# Space Station Electrical Bonding Requirements

## International Space Station

Revision E

## APPENDIX C APPROVED TAILORING/INTERPRETATION AGREEMENTS

**FIGURE C.3.3.2.1-1. CINCH MECHANISM IN THE LAUNCH CONFIGURATION**

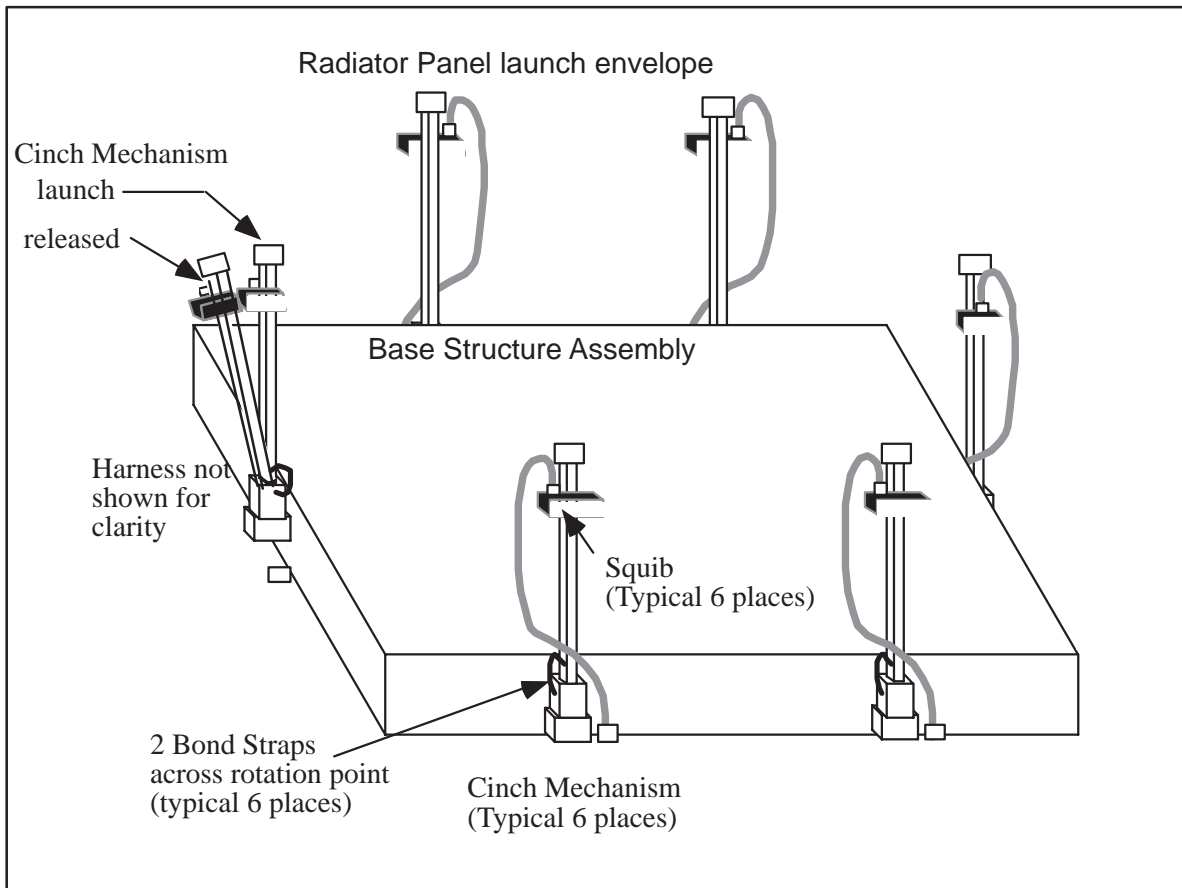
Exception: The radiator cinch mechanisms, Figure C.3.3.2.1-1, (Part Number (PN)s 83-39422 and 83-39421) are allowed to use two parallel Class S ground wires in place of Class R bond strap. The copper ground wires will have a least as great a copper cross section as a Beryllium copper bond strap and will carry full fault currents.

Rationale: The cinch mechanisms are used immediately after the Photovoltaic (PV) Module S1/PV Module P1 segments are powered on orbit. They are only used once in the life of the program and have an EVA override if the electrically driven pyrotechnic device fails. The time between the decision to deploy the array and the firing of the pyrotechnics is expected to be very short (tens of seconds). Figure C.3.3.2.1-2 shows a conceptual diagram of the Electrical Bonding for the Squibs. The Squib circuit is referenced to chassis inside the Squib Fire Unit, Figure C.3.3.2.1-3. The Squib itself is electrically isolated from its chassis by design. For the short time that this device is used, the multiple bond paths that exist, and that the Squib itself is to be isolated from the structure, then not having a true Class R bond path is not significant.

**FIGURE C.3.3.2.1-4 ECOMM GROUND WIRES**

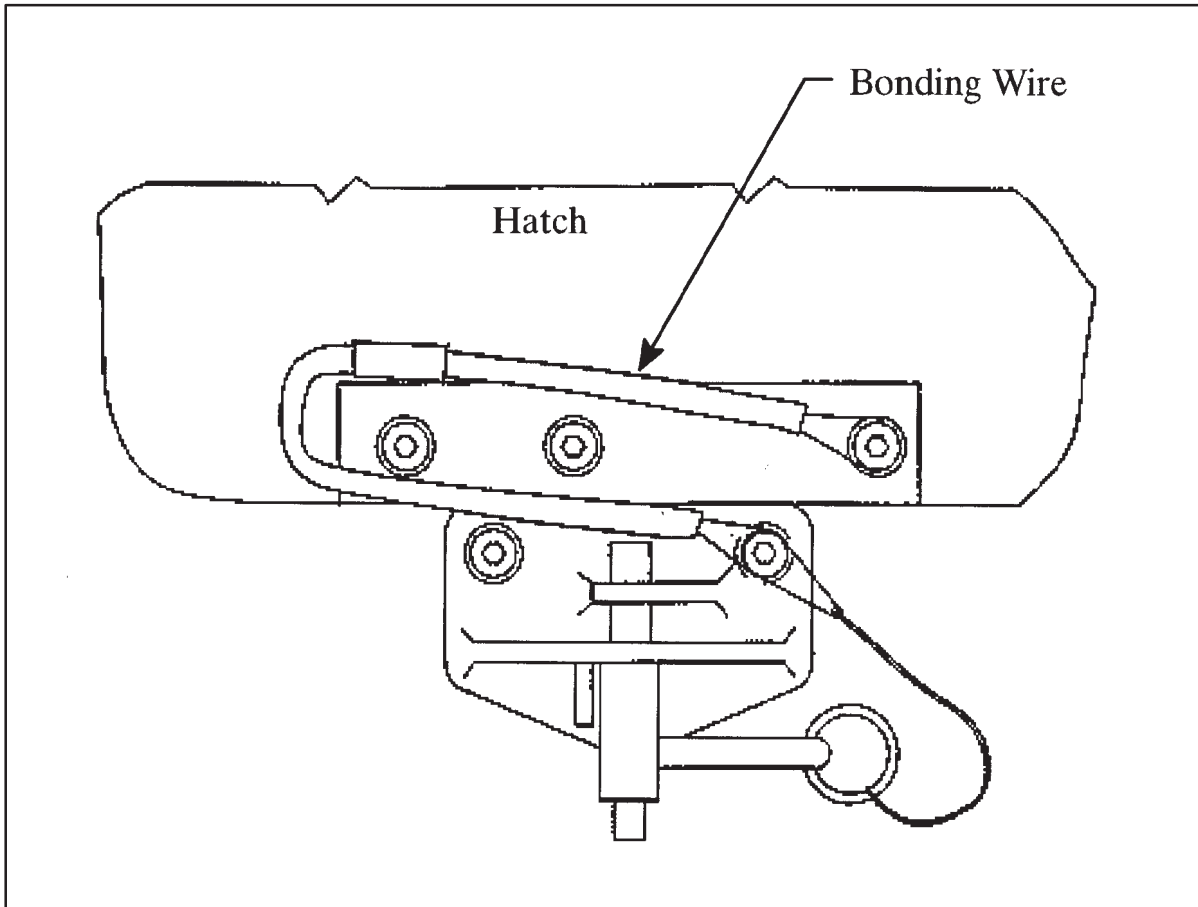
Exception: The Node 1 Port and Starboard hatch ground wires for the Early Communication (ECOMM) are permitted to have breakaway splices from the hatch plates to the Node 1 structure as shown in Figure C.3.3.2.1-4.

- A. This will preclude a violation of safety requirements to be able to open/close the hatches in an emergency.
- B. These wires are contingency grounding wires in the event of a power short within the ECOMM hatch plate cabling.

**FIGURE C.3.1.2.3.1-1 HANDWHEEL DRAWING.**

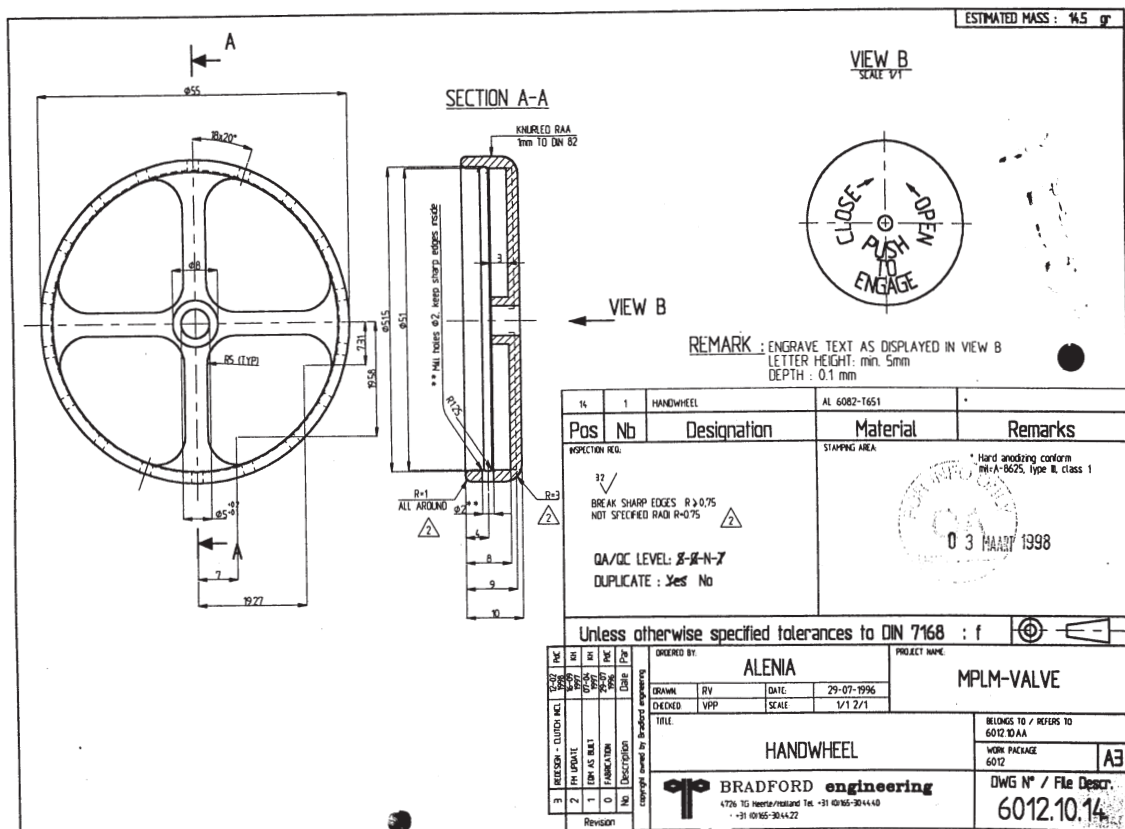
Exception: The Water Modulating Valve/Water On-Off Valve (CI M51110F and PN 60121.AA) is exempted from meeting the bonding requirements of 3.2.1.3.1.

Rationale: This design has already flown in National Space Transportation System flights. The manual override is accessible ONLY when requested by contingency operations; otherwise accessibility is physically precluded by cover panels. The area of the valve is not large enough to allow sufficient charge build-up for a discharge to occur, nor is it in contact with any charging mechanism. See Figure C3.1.2.3.1-1.
